STAFF RECOMMENDATION
1908 19th Avenue South
February 20, 2019

Application: Demolition—Partial; New Construction – Addition and Outbuilding
District: Belmont-Hillsboro Neighborhood Conservation Zoning Overlay
Council District: 18
Base Zoning: R8
Map and Parcel Number: 10412018600
Applicant: Mitch Hodge, Architect
Project Lead: Sean Alexander, sean.alexander@nashville.gov

Description of Project: The applicant proposes to enlarge an historic one and one-half story house with a rear dormer addition and a one-story rear addition, and to construct an outbuilding. **Recommendation Summary:** Staff recommends approval of the proposed addition and outbuilding with the following conditions: 1. The outbuilding roof is revised to not have a dormer in a cross-gable's valley; and 2. Staff shall approve the roof color and window and door selections; and 3. The HVAC units shall be behind the midpoint of the primary building or on the rear. With these conditions, staff finds that the addition meets Section II.B of the *Belmont-Hillsboro Neighborhood Conservation Zoning Overlay: Handbook and Design Guidelines.*	**Attachments** **A:** Photographs **B:** Site Plan **D:** Elevations

SITE PLAN

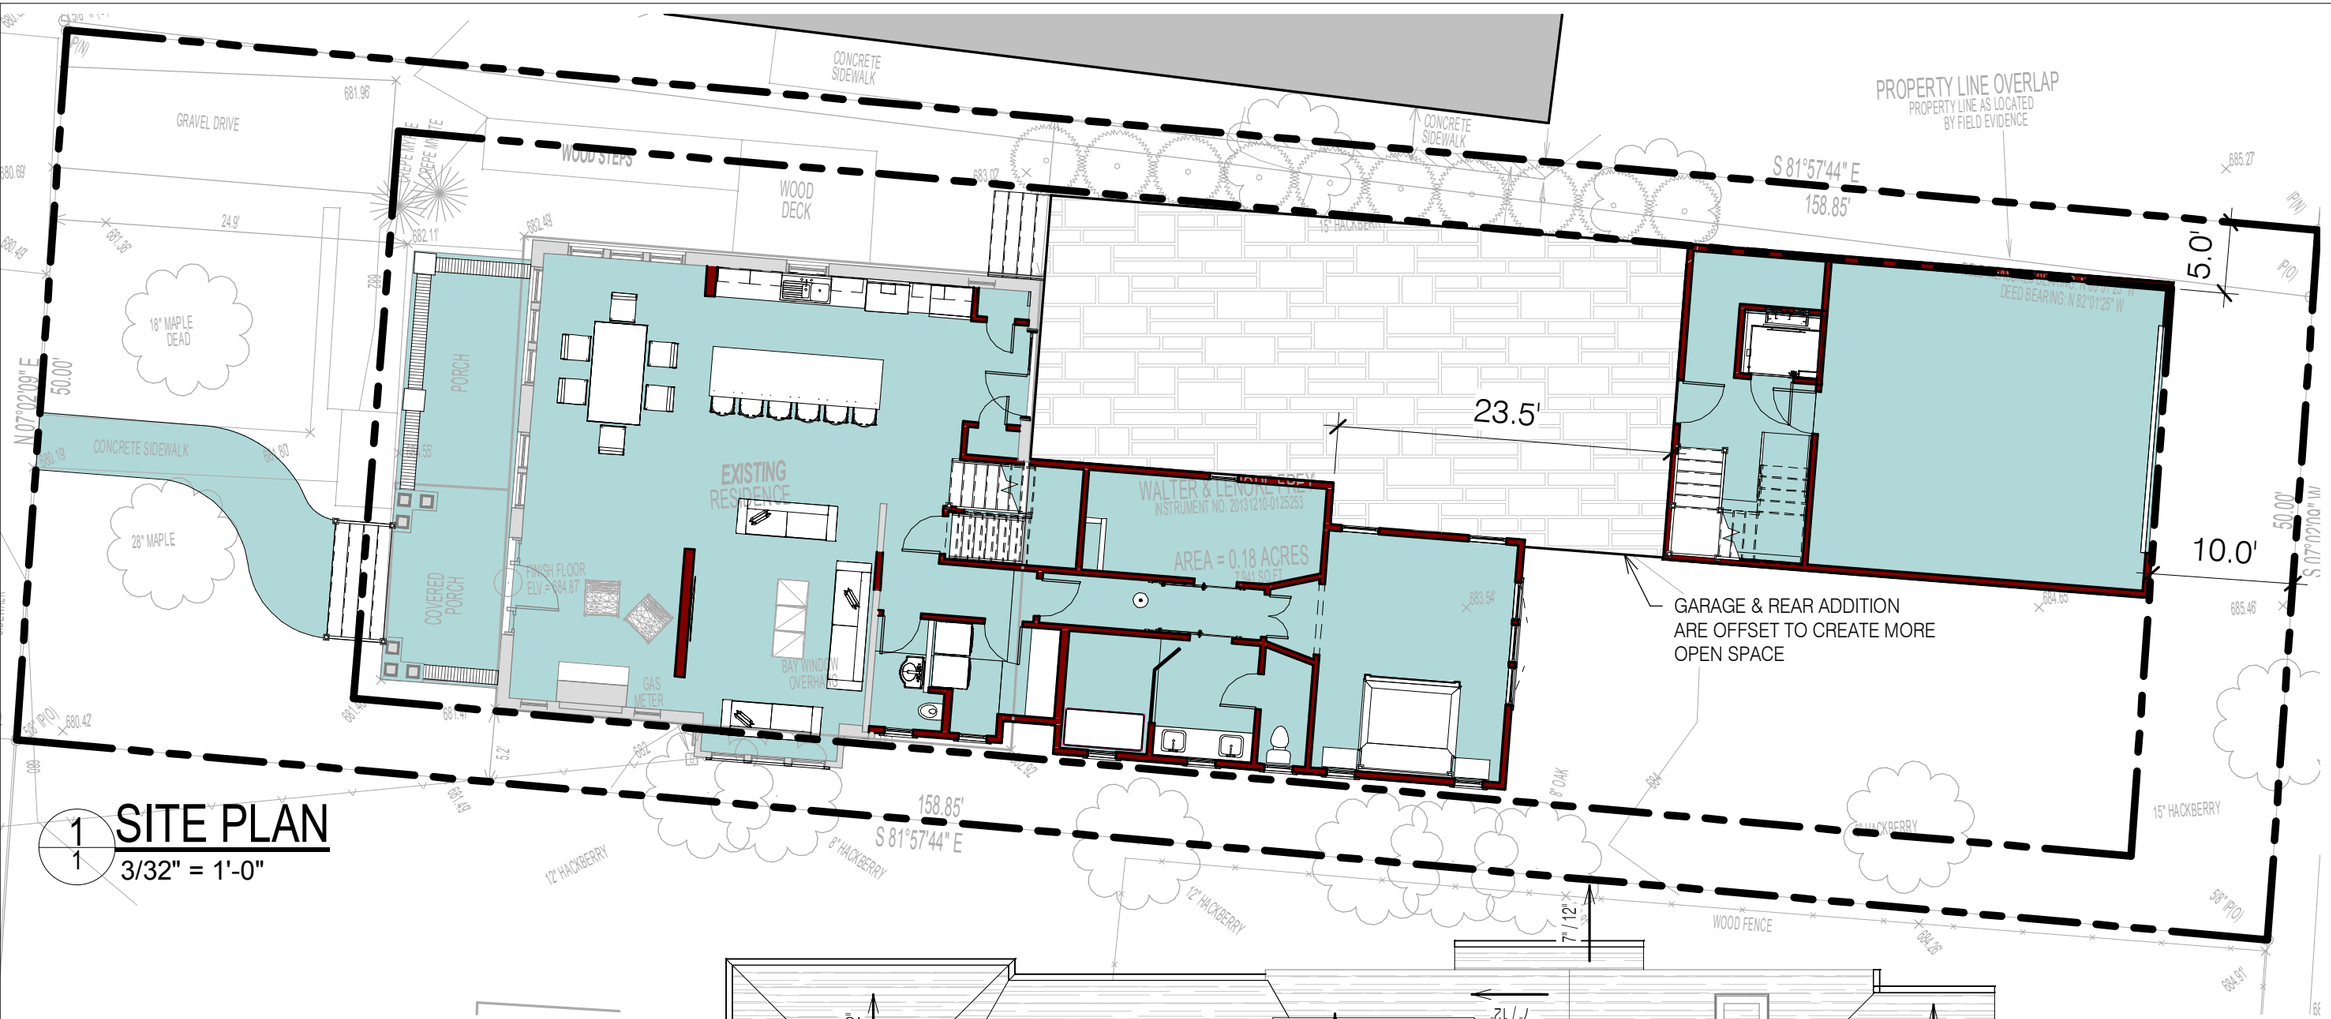
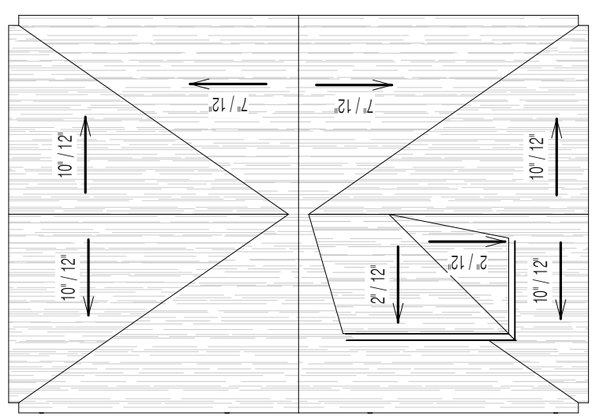
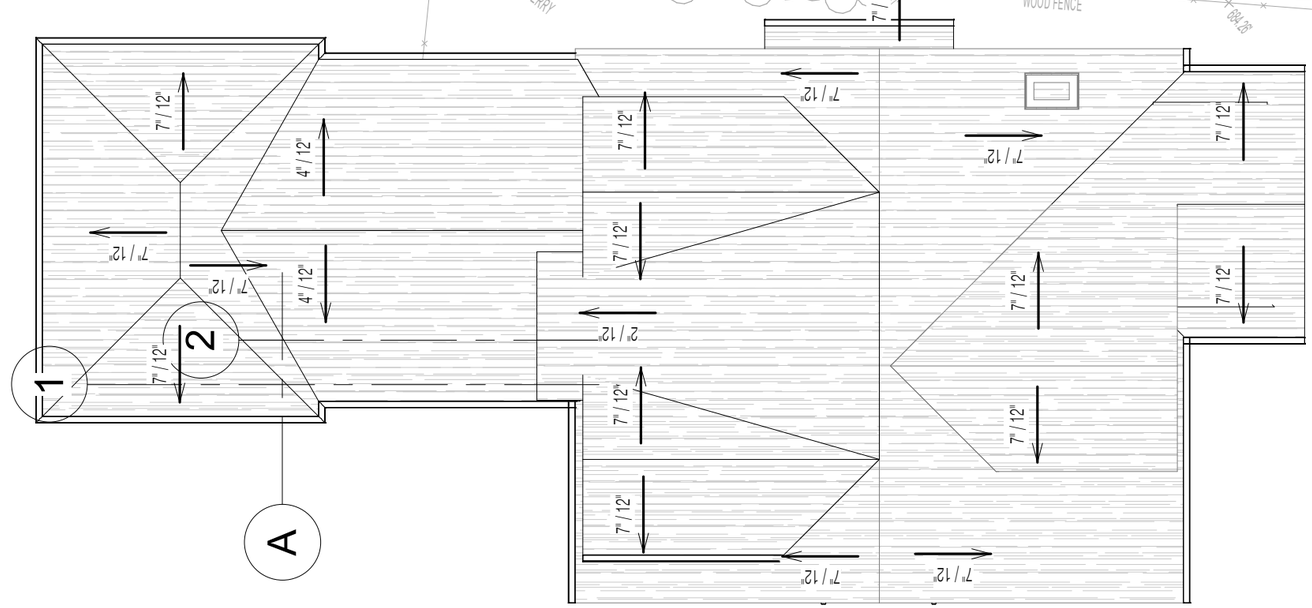
The proposal includes an outbuilding that would only be ten feet (10') from the rear wall of the new addition at one point, whereas the design guidelines say there should be twenty feet (20') between a house and an outbuilding. Although they are less than twenty feet (20') apart, they are only close at one corner. The majority of the outbuilding is more than forty feet (40') from the back of the house. The purpose of the twenty foot (20') separation is to prevent large additions and large outbuildings to the point that the entire lot is essentially built out. In this case, the addition is minimal since it doesn't extend the full width of the house and is only one-story. In addition, they will not be visible simultaneously because the outbuilding is shifted to the left side of the lot and the addition is shifted to the right side of the lot. Staff finds that the proposal will meet section II.B.1.c of the design guidelines.

Appurtenances & Utilities: The proposal indicates that the existing gravel driveway on the left side of the house will be retained, however because the driveway will not continue to the rear Staff recommends that the driveway is removed. A new driveway will be added from the alley at the rear to access a new outbuilding. An existing side staircase to an upperstory door and deck will be removed. The HVAC unit locations are not indicated. Staff asks if the HVAC units are relocated, that they be behind the midpoint of the building in order to meet Section II.B.1.h of the design guidelines.

1. The outbuilding roof is revised to not have a dormer in a cross-gable’s valley; and
2. Staff shall approve the roof color and window and door selections; and
3. The HVAC units shall be behind the midpoint of the primary building or on the rear.

ELEVATIONS

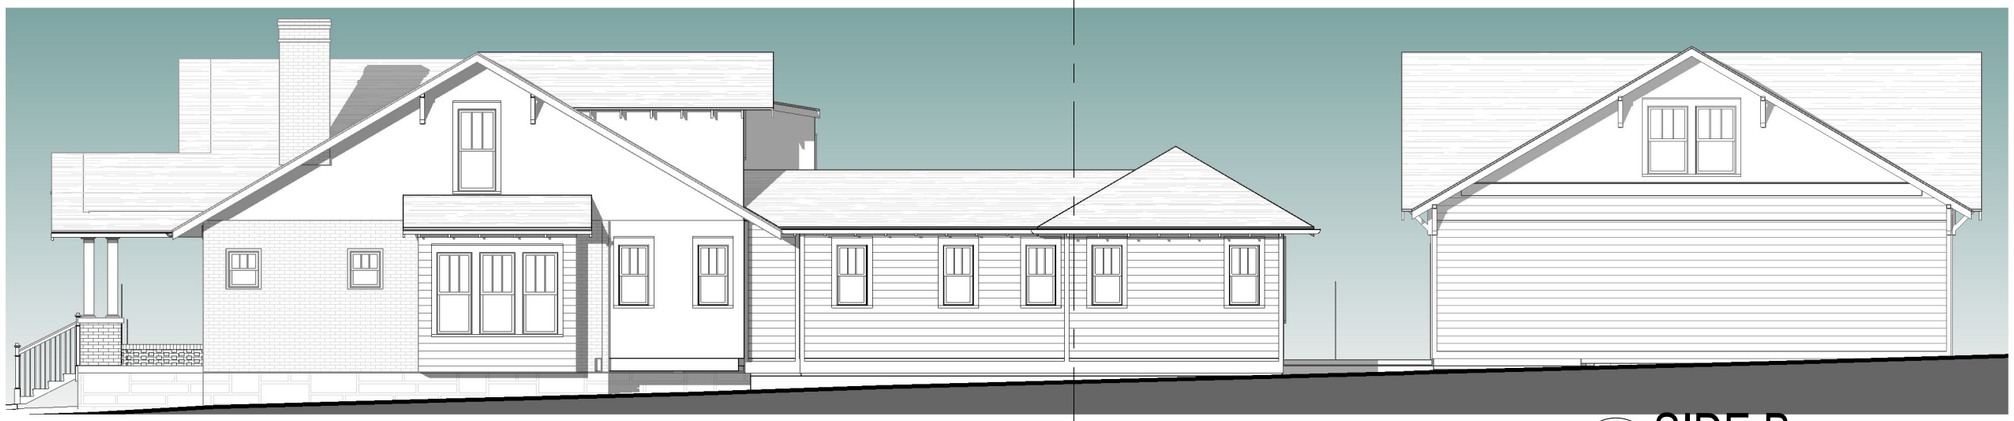
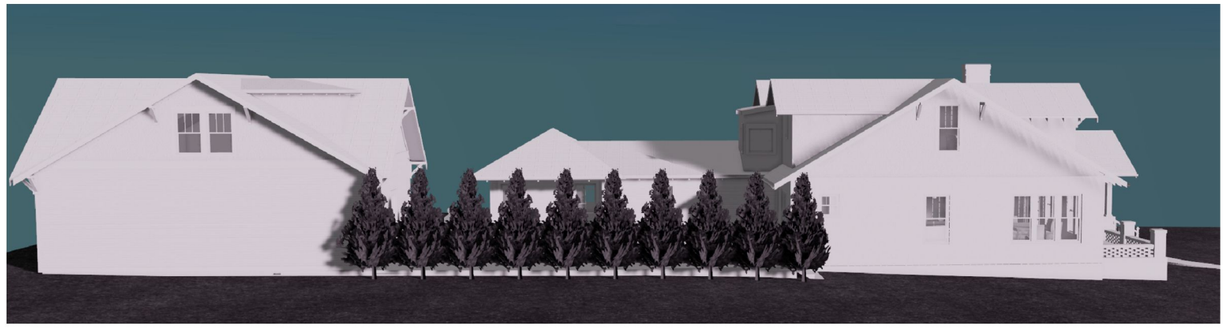
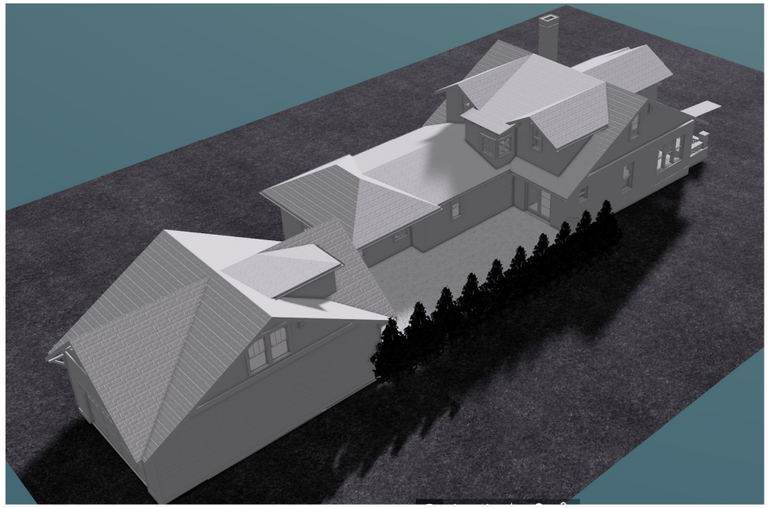
The outbuilding's roof will be cross gabled, with a dormer in one of the valleys. Staff recommends that the roof be revised to not have a dormer, as dormers are not typical of cross-gabled roofs. With that condition, the form and pitch of the roofs are similar to historic outbuildings, and Staff finds that the project would meet section II.B.1.h.1 of the design guidelines.
